SERVICE BULLETIN

SUBJECT CHANGE IN LOCK PAWL 1991-1992
CHEVROLET LUMINA (PASSENGER 4 DOOR CAR ONLY)

No. AS-1119
DATE 4-8-91
FILE IN Bulletin
Binder

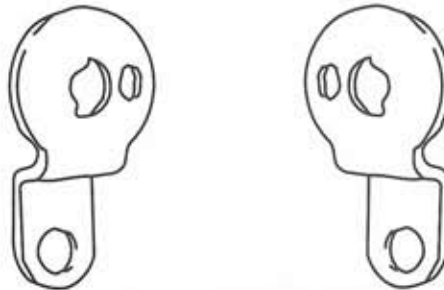
When servicing the door locks of the above subject. Please replace the door pawl with the new offset door pawl. The new offset pawl allows better operation of the lock.

OLD

321556 UNIVERSAL

NEW

321558 RH
321559 LH
